**CERTIFICATE OF COMPLIANCE  
FOR RADIOACTIVE MATERIAL PACKAGES**

1.	a. CERTIFICATE NUMBER	b. REVISION NUMBER	c. DOCKET NUMBER	d. PACKAGE IDENTIFICATION NUMBER	PAGE	PAGES
	9358	5	71-9358	USA/9358/B(U)F-96	1 OF	34

- a. ISSUED TO (*Name and Address*)  
TN Americas LLC  
7160 Riverwood Drive, Suite 200  
Columbia, MD 21046
- b. TITLE AND IDENTIFICATION OF REPORT OR APPLICATION  
TN-LC Transportation Package Safety Analysis Report, Revision No. 9.

Figure 5  
PRA Insertion Locations for WE 16x16 Class Assemblies

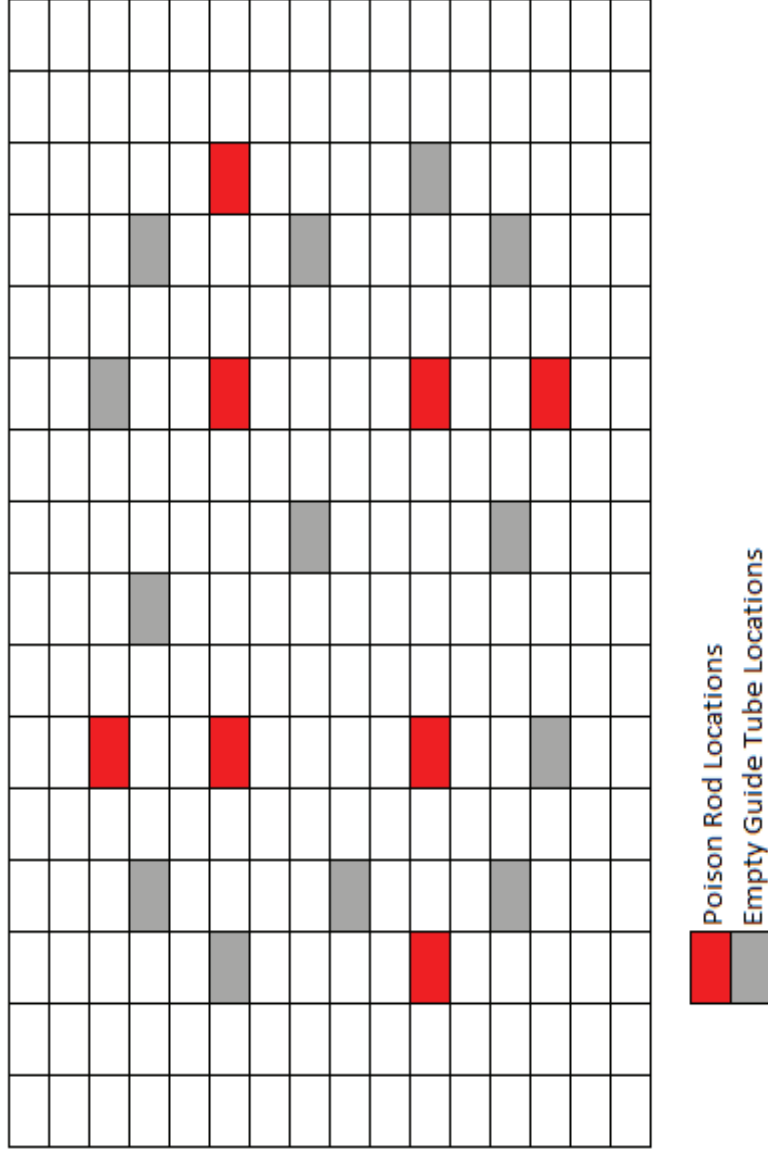
A new WE 16x16 fuel class was added as authorized contents and revised notes were provided for WE 17x17, W 14x14, CE 16x16, and WE 16x16 fuel designations. PRA requirements and insertion locations for WE 16x16 fuel were also added.

- (g) Tables 15a and 17 a were added to the Fuel Qualification Tables for a PWR Fuel Assembly - 3.10" Lead Thickness and 21 PWR Fuel Rods (UO<sub>2</sub>) - 3.10" Lead Thickness, respectively. The corresponding notes were also updated. Table 5 was added to show the PRA insertion locations for WE 16x16 Class Assemblies.
